MS-5012 Field Software Change Procedure

Document 50194 Rev B 3/16/95 ECN 95-133

Firmware Change

PROM Replacement

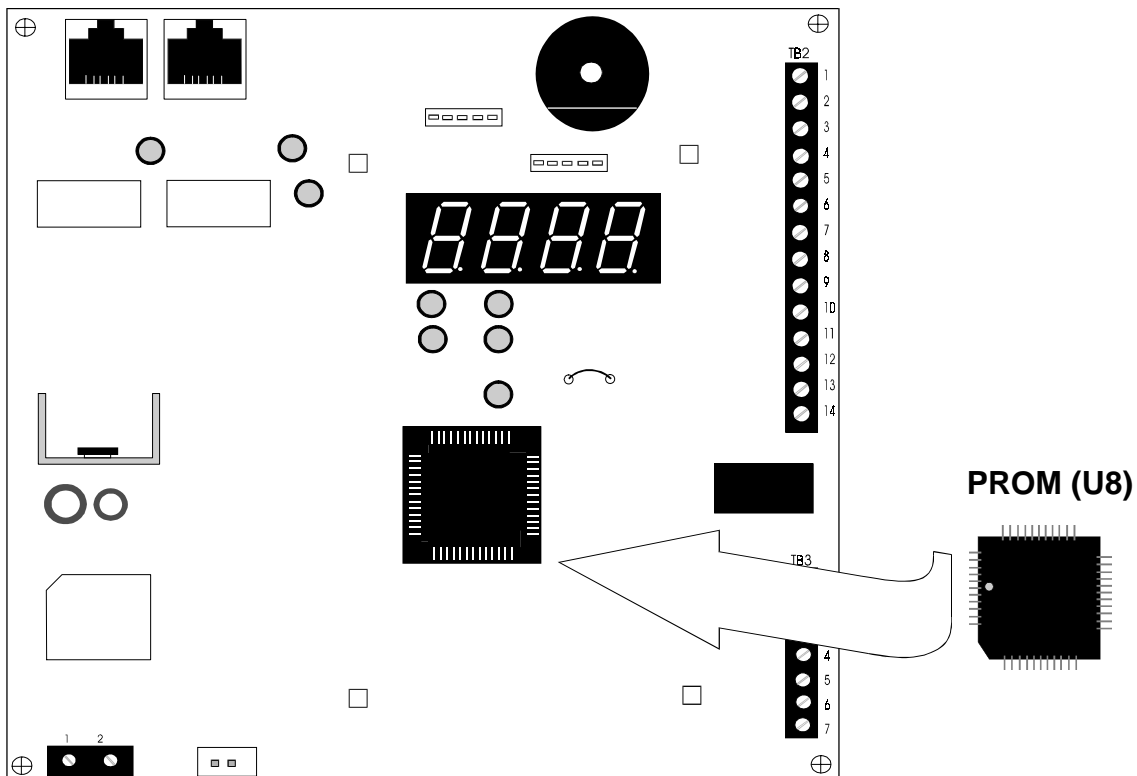
Observe proper orientation of any IC removed or installed! To replace the PROM, complete the following steps:

1. Once all power has been removed, disconnect any option modules (if installed).
2. Gently remove membrane keypad from circuit board, but do not disconnect cable from circuit board. (Note that the keypad's four supports snap into the circuit board).
3. Locate U8 (center of the board).
4. Gently loosen and remove the PROM from U8.
5. Install the replacement PROM in location U8. Observe proper orientation! The dot on the IC should be positioned to the left and the flattened corner of the IC should align with the flattened corner of the socket. Use care to insure that the PROM's pins are not bent or broken during insertion.
6. Reconnect power supplies.
